**LANEY CHILDCARE
CENTER IMPROVEMENTS – PHASE II**

BID NO. 20-21/01

**Laney Childcare Center Improvements – Phase II
900 Fallon Street Oakland, CA 94607**

ADDENDA No. 2

SITE PLAN
A1.00

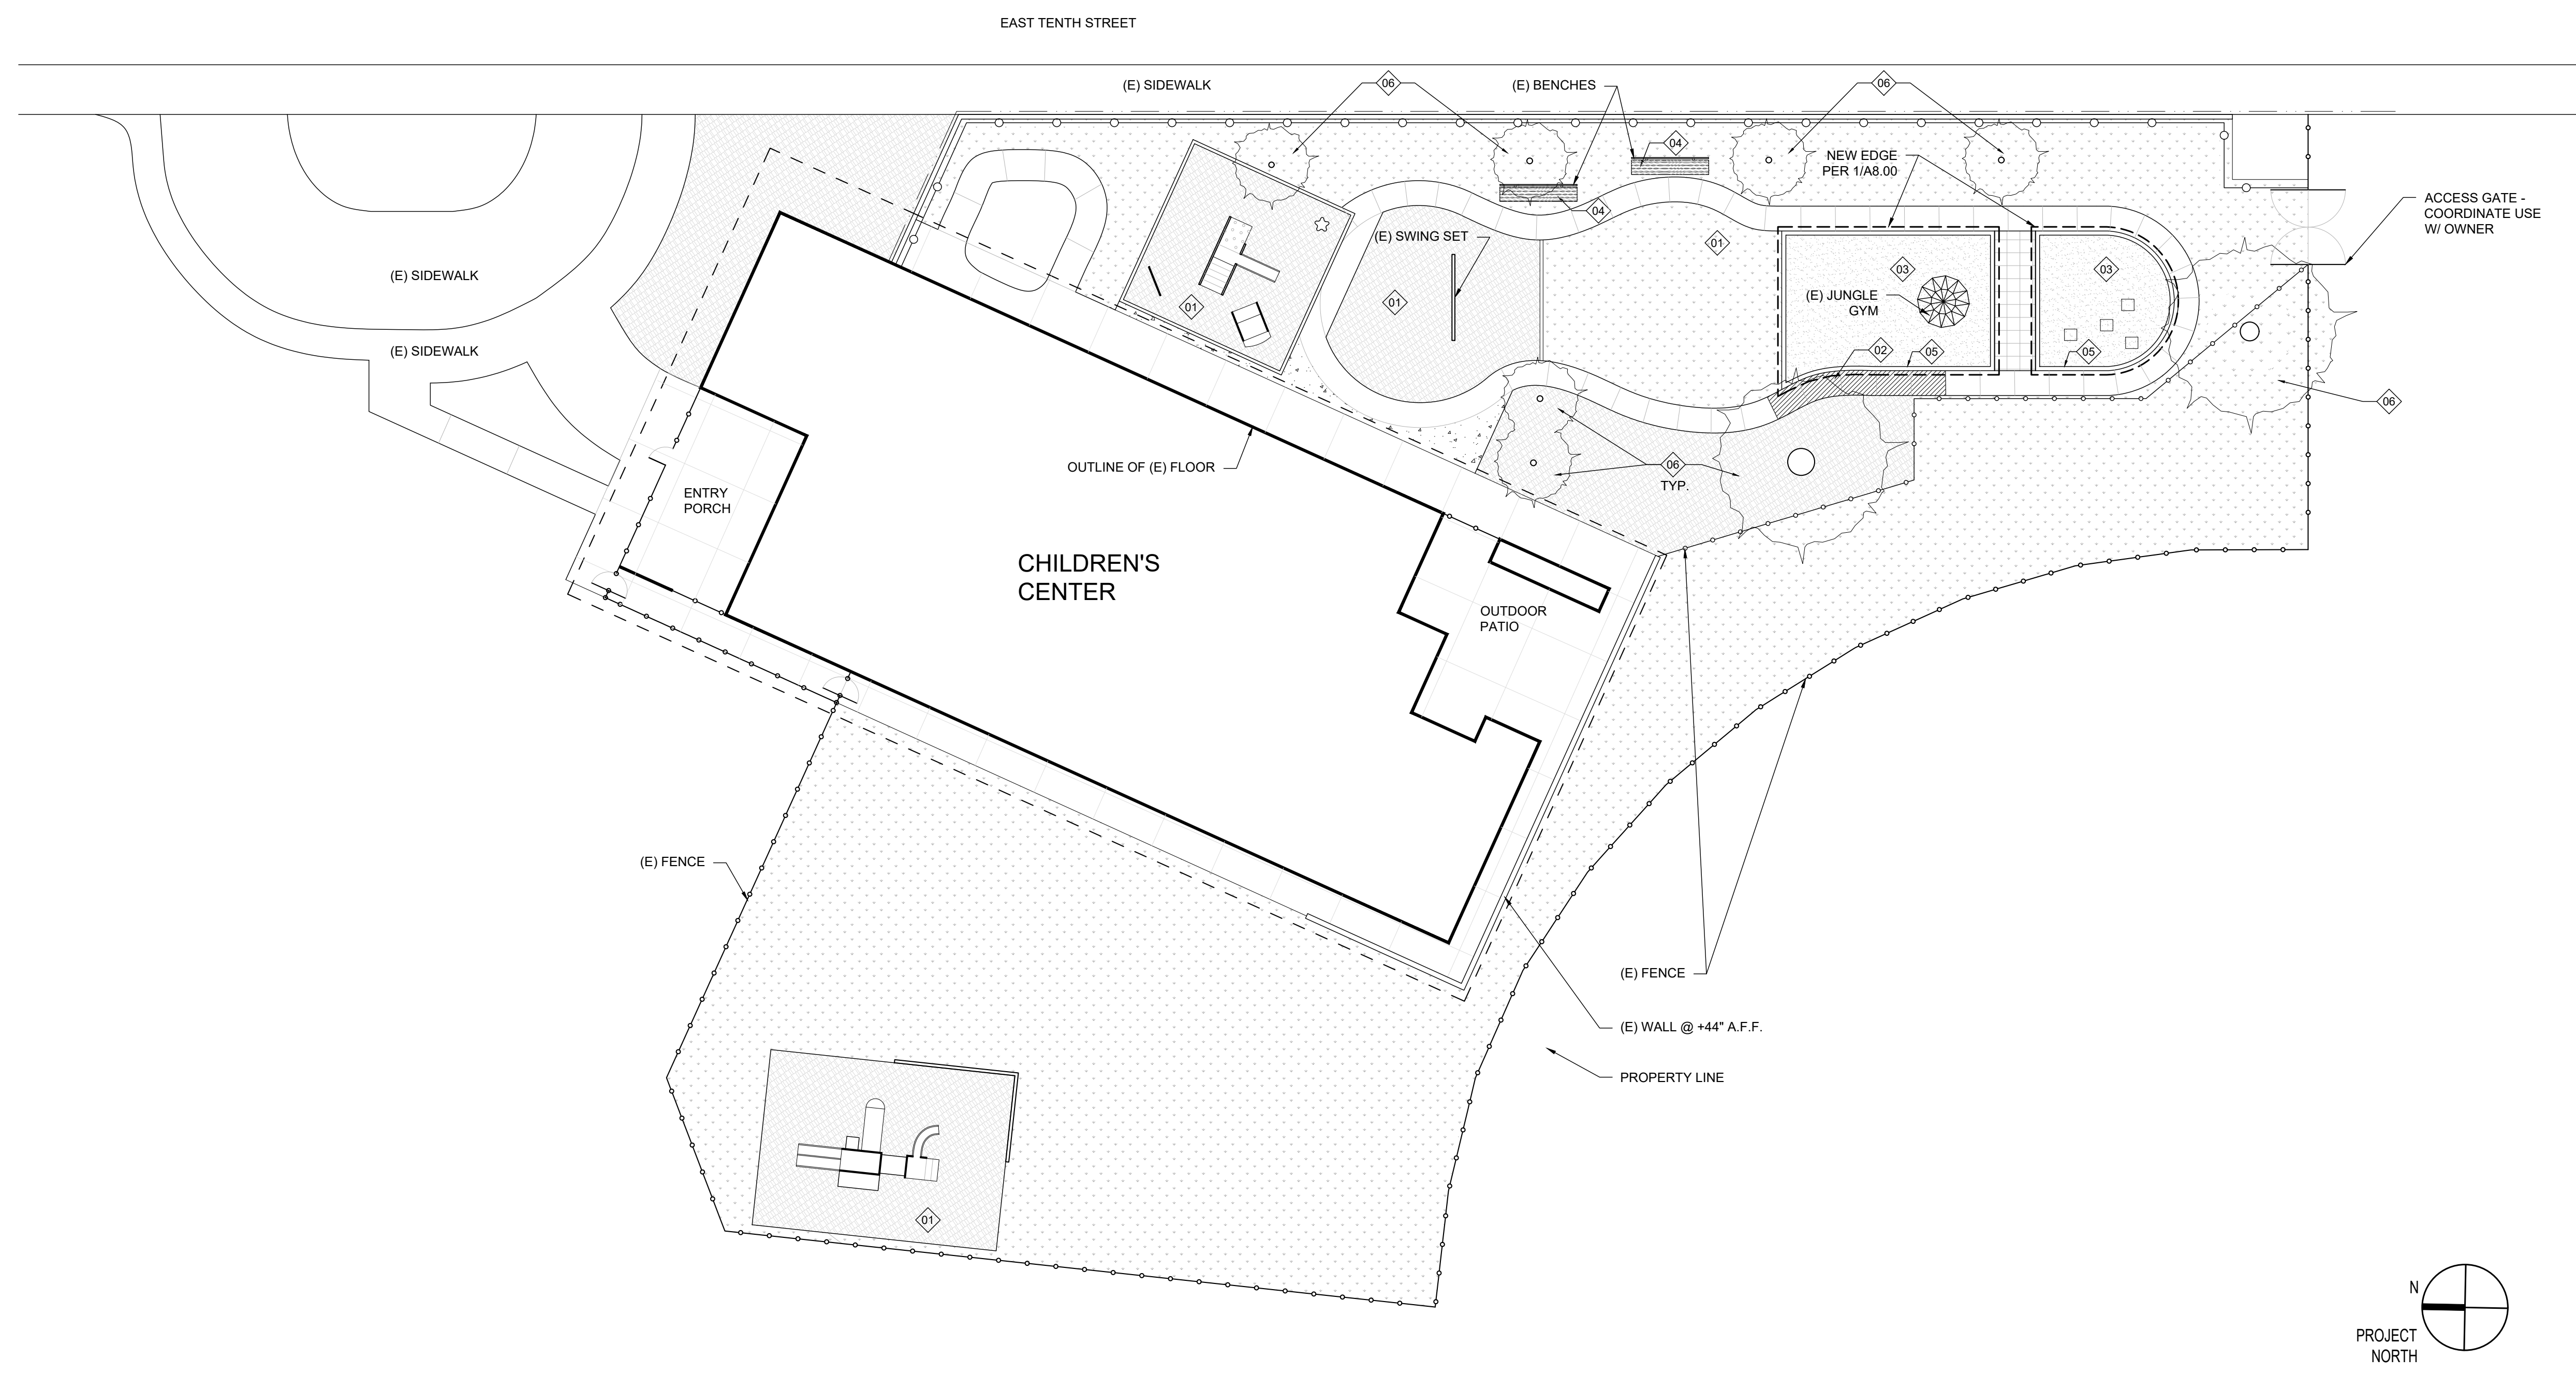
6. Note 2 on A1.00 calls for areas of concrete to be ground down where tree roots have caused the concrete to heave. Per A0.10, this area is within the accessible path of travel.

- a. Is the awarded contractor responsible for verifying that all existing concrete pathways meet all slope requirements to meet State and Federal accessibility requirements?

- b. Is awarded contractor responsible for removing and replacing any non-conforming concrete pathways?

- c. For areas where non-conformance is caused by tree roots, what are the requirements for cutting or working around said roots?

Response: Please refer to attachment

Response: Please refer to attachment

Response: Please refer to attachment

LEGEND	SHEET NOTES	GENERAL NOTES
<p>WOOD CHIPS TO BE ENGINEERED WOOD FILL (EWF)</p> <p>CONCRETE</p> <p>GRASS</p> <p>SAND TO BE PLAYSAND (QUIKRETE #1113 OR APPROVED EQUAL)</p> <p>CONCRETE TO BE GRIND, PATCH AND CASE ALL CONCRETE EDGES THAT EXCEED 1/4" DIFFERENTIAL (MAX.)</p> <p>DASHED OUTLINE OF ROOF OVERHANG</p>	<p>01 REMOVE (E) WOOD CHIPS IN PLAYGROUNDS AND REPLACE W/ EWF. (E) BORDER TO REMAIN</p> <p>02 HATCHED AREA AT CONCRETE WALK: GRIND AND/OR PATCH CONCRETE EDGES THAT EXCEED 1/4" VERTICAL DIFFERENTIAL (MAX.) TO CONFORM TO ACCESSIBLE STANDARDS - DO NOT EXPOSE ANY REINFORCED STEEL</p> <p>03 REMOVE (E) SAND, PREP PER TYP. SECTION DETAIL AND FILL W/ PLAY SAND</p> <p>04 PREP AND SEAL ALL WOOD BENCHES (TYP.) - SEE PAINT SPECIFICATIONS FOR ADDITIONAL REQUIREMENTS</p> <p>05 DEMO (E) WOOD BORDER AND INSTALL NEW CONT. BORDER AS SHOWN (TYP.)</p> <p>06 TRIM AND PRUNE ALL TREES IN ALL YARDS EVEN IF NOT SHOWN IN PLAN (V.I.F.). LANDSCAPE ARBORIST WILL INSPECT AND REMOVE WEAKENED BRANCHES. CERTIFIED ARBORIST SHALL INSPECT AND PROVIDE DIRECTION FOR OVERALL TREE PRUNING AND BRANCH REMOVAL FOR ANY SAFETY CONCERNS (TYP.) - SEE SPECIFICATIONS FOR ADDITIONAL REQUIREMENTS</p> <p>07 SEE A8.00 FOR ADDITIONAL INFORMATION REGARDING ENTRY GATE</p>
